MECKLENBURG COUNTY
DEPARTMENT OF ENVIRONMENTAL HEALTH

PROPOSED PLOT PLAN

Subject: Property located at 4403 Kemper Lane
File: 21434

MODIFIED SEWAGE DISPOSAL
LOT NO. 5 KEMPER DOWNS
4403 KEMPER LANE
(OLD) 4428 KEMPER LANE

PLOT PLAN

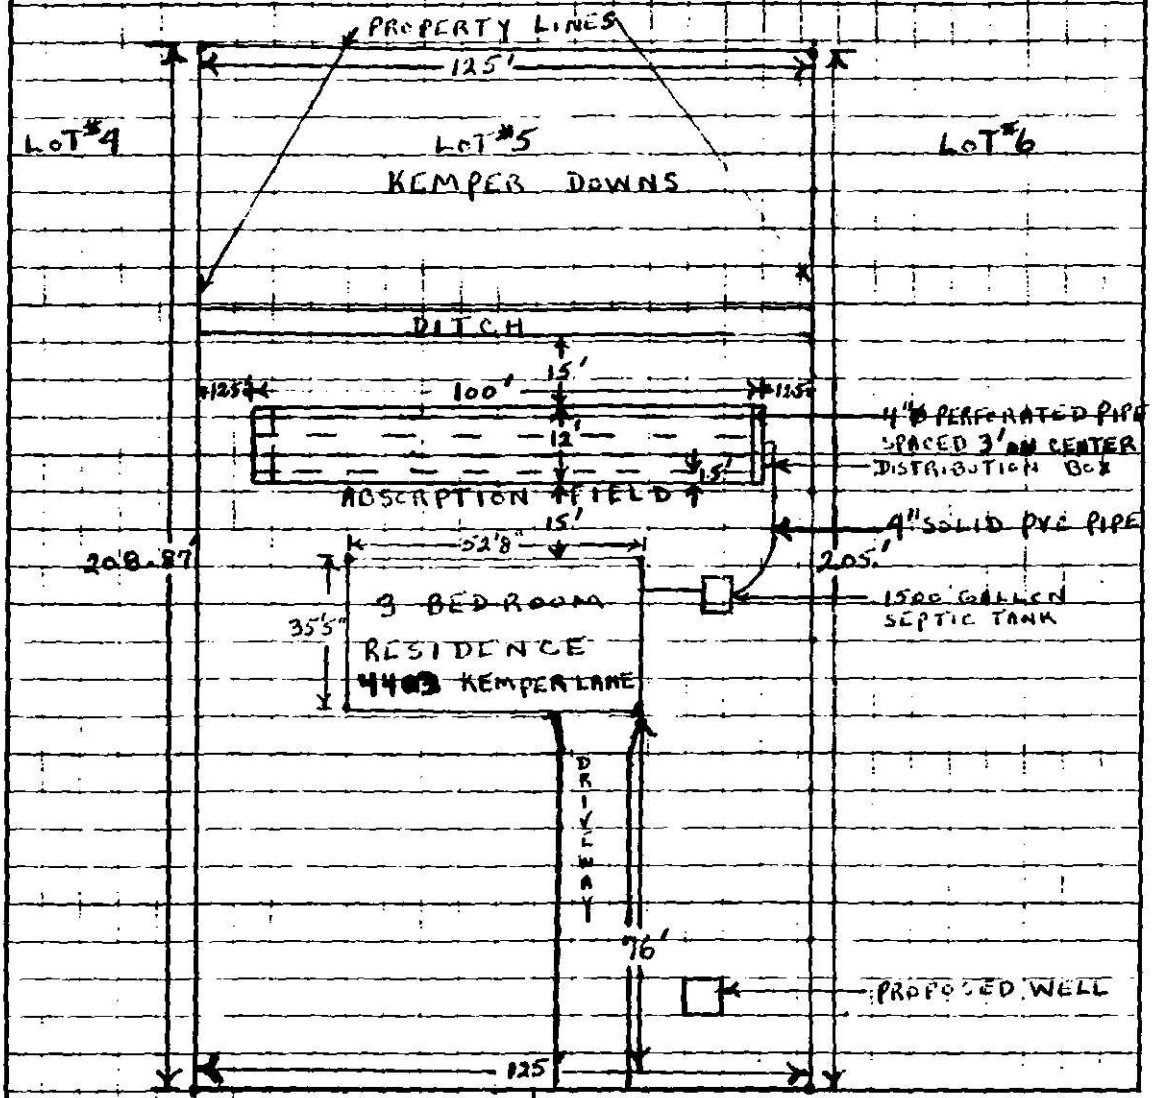
1. The site evaluation report classifies the property as unsuitable as to soil depth in test Area I. However, State Sewage Regulations allow for "modified" systems provided certain design stipulations are met. In the "Pacolet" area soil depths range from 30-36 inches with the deeper soil located towards the rear of the property. Your proposal appears to be situated in the deeper soil as indicated on the plot plan; however, the bed system must be replaced with a trench system to be considered for approval. The trenches must remain shallow, not to exceed twenty-four (24) inches. The trenches should not exceed thirty-six (36) inches in width and lines must be nine (9) feet on center. The total system width should be approximately thirty (30) feet. The lot must be able to also accommodate a 100% repair area (1200 square feet of area). The repair area is not indicated on the plan.

2. The well may not be closer than fifty (50) feet from any part of the sewage disposal system or repair area.

For these reasons, the plans as submitted are disapproved. If desired, we will reopen the review upon submission of revised plans.

PLOT OF SYSTEM

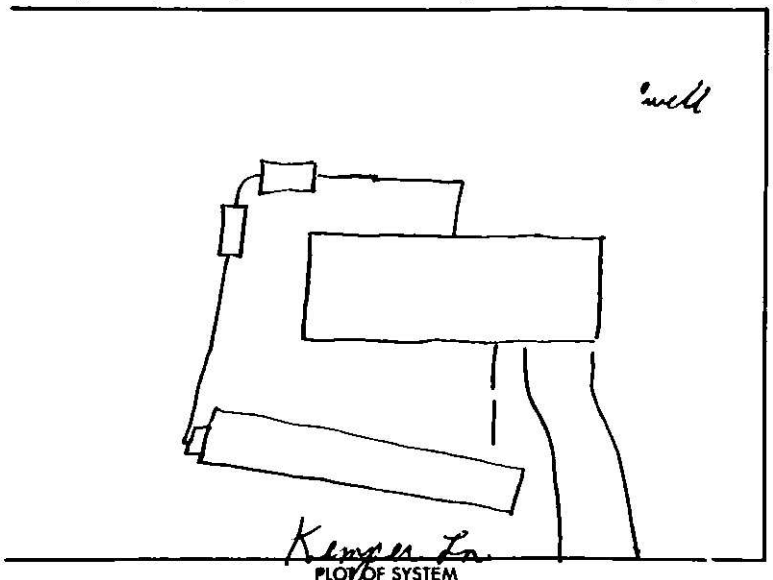
NAME OF OWNER John Epley
LOCATION OF PROPERTY 4403 Kemper Ln.
Comments: Bed 15'X90'X12" stone. Bed system installed due to limited area. Brick walkway added to the front steps and was not shown on the original plot plan Application rate .4
